Iowa Electric Light and Power Company

NG-82-2348

Re: Duane Arnold Energy Center

Subject: Response to Inspection Report 82-11

Figure PR-5.1 Alternate Testing Approach for Determination of Hydraulic Change

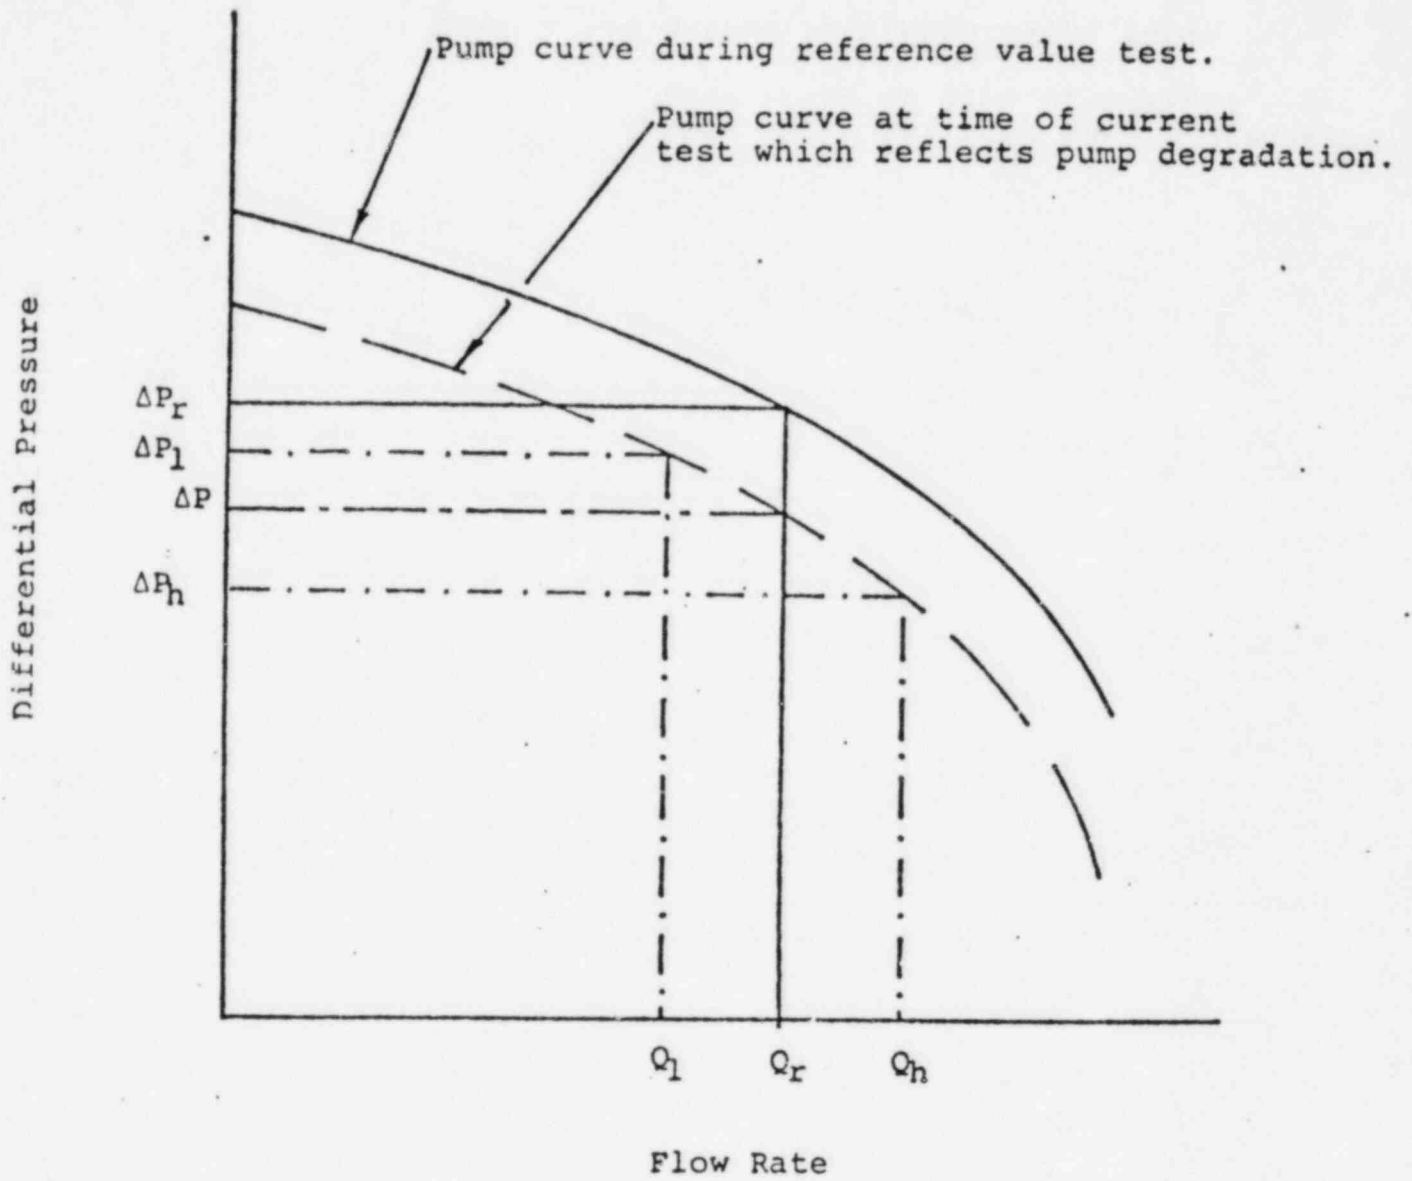
BASIS FOR RELIEF: Operating experience has shown that flow rates (the independent variable during inservice performance testing for these pumps) cannot be readily duplicated with the present flow control systems. Also, efforts to exactly duplicate flow rate reference values would require excessive valve manipulation which could result in damage to the valve or operator. Based on these limitations, DAEC proposes to implement an alternate means of determining whether pump degradation has occurred.

ALTERNATE TESTING: Reference values will be established for flow rate (Q_r) and differential pressure (ΔP_r) during the reference value tests. However, instead of exactly duplicating Q_r during subsequent inservice performance tests, a flow rate (Q_l) lower than Q_r will be obtained and recorded along with the corresponding differential pressure (ΔP_l). Next, a flow rate (Q_h) higher than Q_r will be obtained and recorded along with the corresponding differential pressure (ΔP_h). These two points, ($Q_l, \Delta P_l$) and ($Q_h, \Delta P_h$), define a small portion of the pump curve which intersects the vertical line defined by Q_r (See

Figure PR-5.1). Using linear interpolation between the two points, a differential pressure (ΔP) will be computed from the intersection of the pump curve and the vertical line established by Q_r . The computed value for ΔP will be recorded and compared to the ASME allowable ranges for differential pressure (Table IWP-3100-2) which were determined from ΔP_r .

The alternate testing procedure described above assumes that the pump curve is nearly linear between Q_l and Q_h . Procedural limits for Q_l and Q_h have been established and individual pump curves have been analyzed to ensure near linearity between Q_l and Q_h .
